Notice of Intent

Sundry ID: 2838140

Type of Action: APD Change

XTO respectfully requests approval to make the below listed changes to the approved APDs.

Previous Design: 4-String Design – Engineered Weak Point**[Figure F] 4 String – 2nd Intermediate casing engineered weak point**

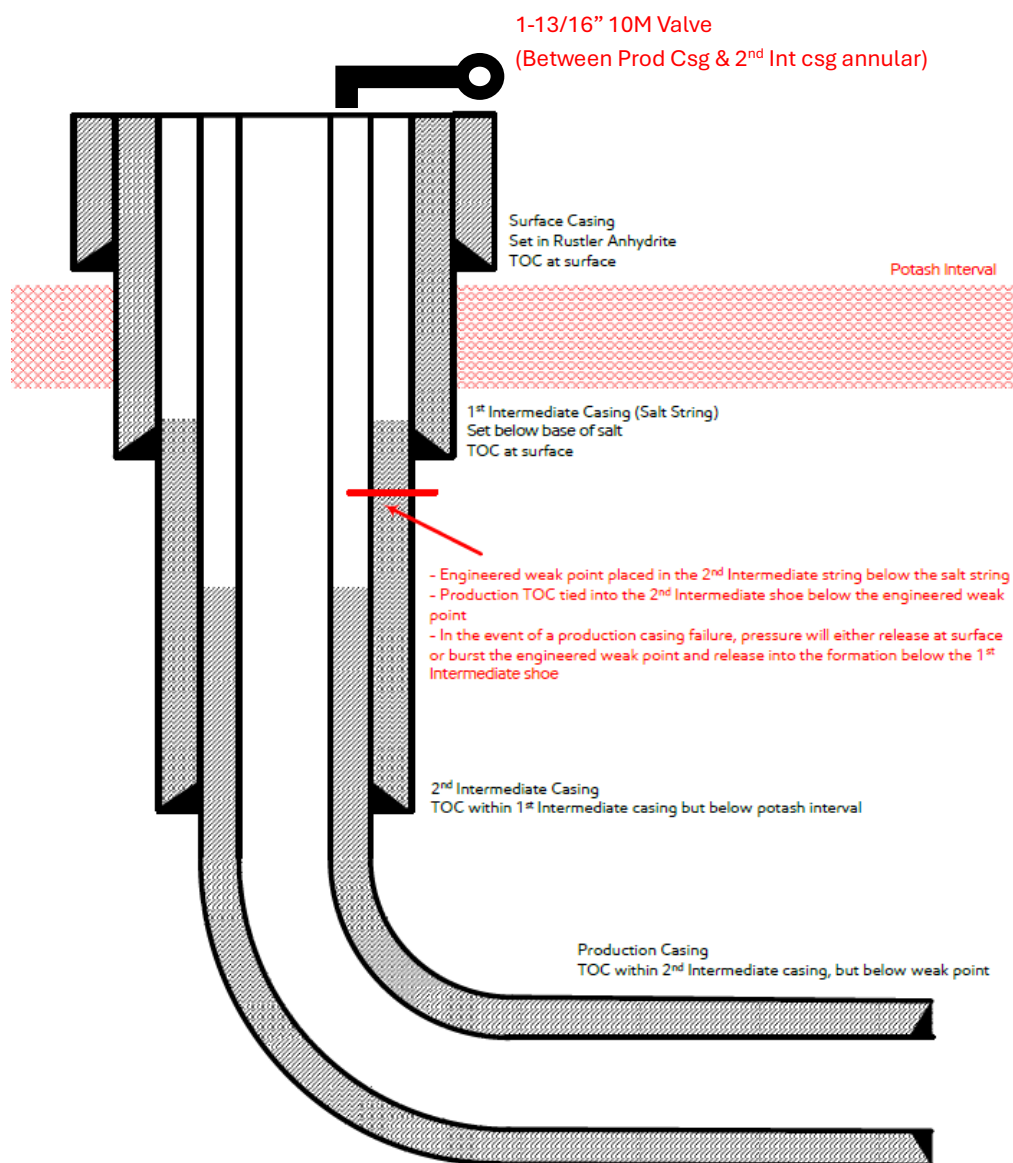
1. Casing design to be changed from the "4-String Design – Engineered Weak Point" (FIGURE F) to the "4-String Design – Open 1st INT x 2nd INT Annulus" (FIGURE D). An open annulus will be utilized and monitored during completions operations.

- 1) Alignment with KPLA requirements per schematic per schematic below, with engineering weak point casing design and utilizing new casing that meets API standards.
- 2) Contingency plans in place to divert fluids away from salt interval in event of production casing failure.
- 3) Intermediate 2 casing will consist of a primary cement job with TOC at the top of the Brushy Canyon formation within the Delaware Mountain Group.
 - a. Bradenhead squeeze to be completed after primary cement job to tie back TOC to intermediate 1 "Salt string" at least 500' but with top below Marker Bed 126 "Potash Interval".
- 4) Production cement to be tied back no less than 500' inside previous casing shoe (intermediate 2 casing) and below the engineered weak point.

[Figure D] 4 String – Uncemented annulus between 1st and 2nd intermediate casing strings

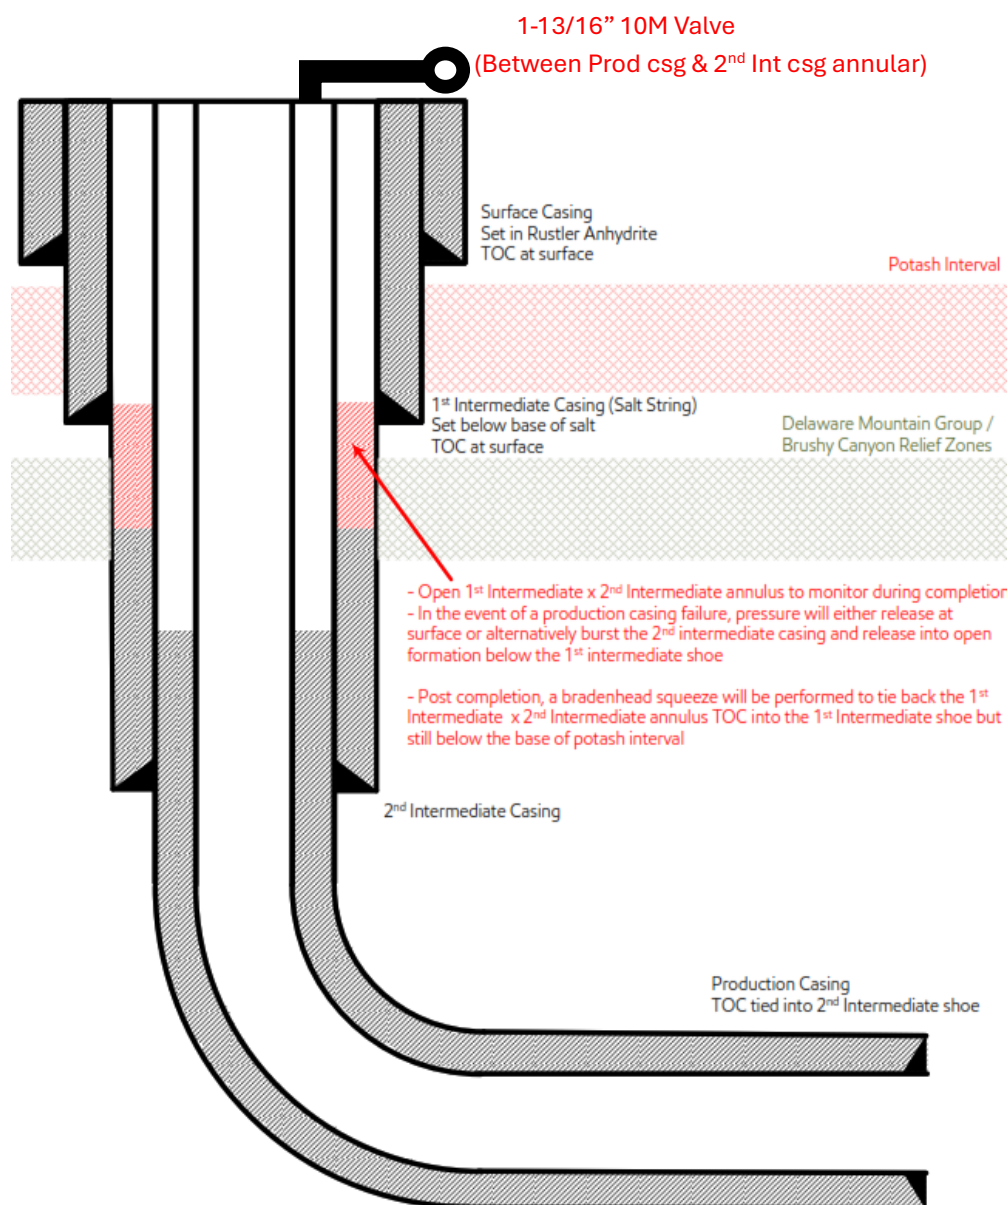
New Proposed Design: 4 – String Design – Open 1st Int X 2nd Int Annulus (ICP 2 below relief zone)

- 1) Alignment with KPLA requirements per schematic above, leaving open annulus open for pressure monitoring during frac and utilizing new casing that meets API standards.
- 2) Contingency plans in place to divert fluids away from salt interval in event of production casing failure.
- 3) Intermediate 2 bradenhead squeeze to be completed within 180 days to tieback TOC to salt string at least 500ft but with top below Marker Bed 126.
- 4) Production cement to be tied back no less than 500ft inside previous casing shoe.

Post completion, bradenhead squeeze will be performed to tie back the 1st intermediate x 2nd intermediate annulus. TOC will be placed into the 1st intermediate shoe but still below the base of Potash interval.
